Product change notification (PCN)

Title / short description	Change in ST 2,5 housing
Affected article category	Terminal blocks
Change category	Form and appearance
Change number	PBE160082-00

Change of ST 2,5-Housing

ST 2,5 GEH

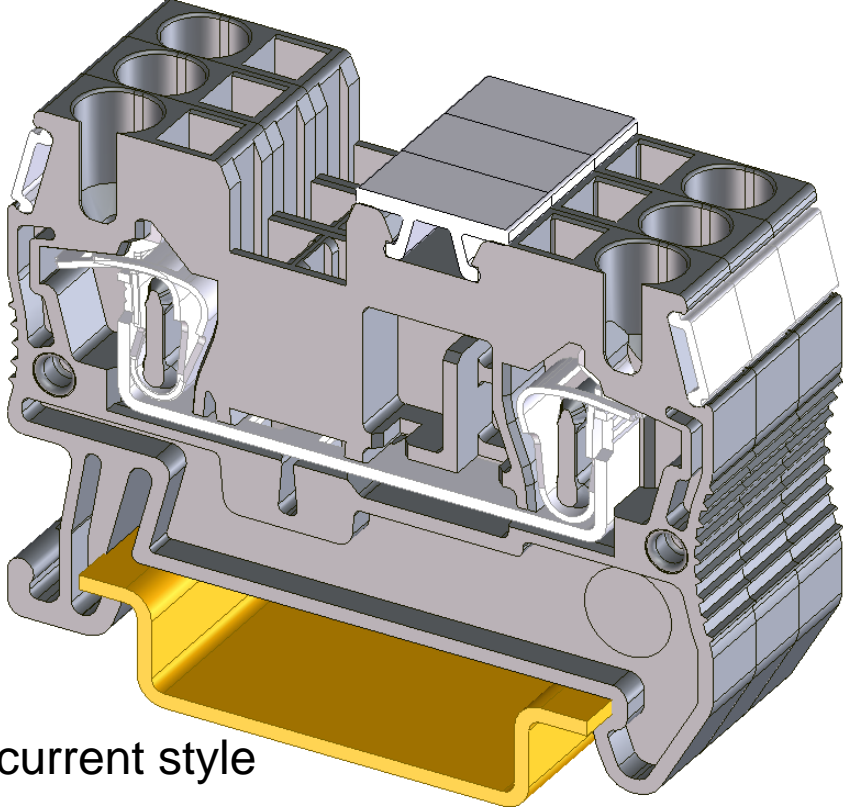
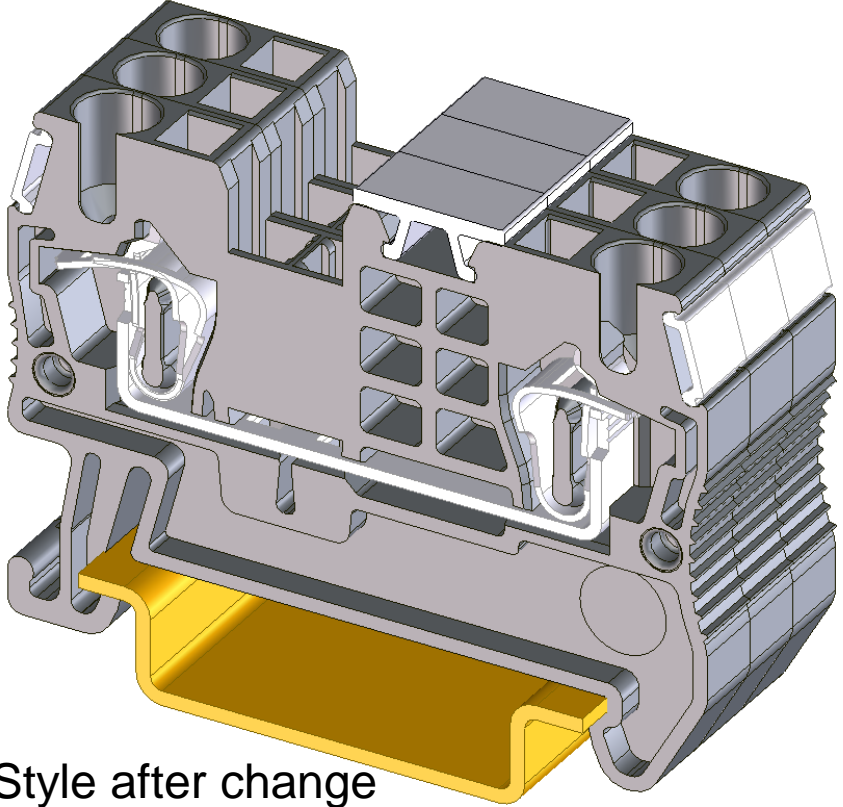
Improvement in housing stability under special ambient conditions

Bracing of housing

New ribbing arrangement

- Due to capacity expansion in China a new injection mould is required
- A new design in the moulding will be realized
- The new design will improve the stability of the housing for extrem conditions
- In other production locations, the old design will be valid till a maintenance of the moulding tool will be necessary
- Over the time all other production location will get successively the new design
- technical rates and dimensions remain the same
- Mixing of inventory is possible

both styles are valid
